□  
**PRODUCT CHANGE NOTICE**  
PCN Form (D4-E000-73)

**PCN#10-012**

**MODEL(S) AFFECTED:**

Attachment to [PCN#10-012](#)

### Outline Dimensions

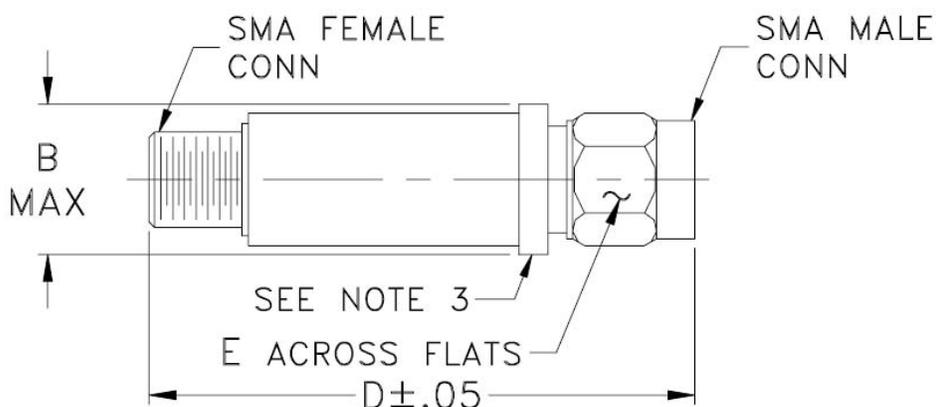
Modification of Unibody to include 'flats' to assist in SMA connector nut torquing.

- Change of outline per attached drawing. No change in performance

- Changes made to enhance customer ability to torque the SMA connector nut by providing a flat surface for wrench.

1. Case material: Brass.
2. Case finish: Nickel plate.
3. Round Flange may have .312 Across Flats in some models.
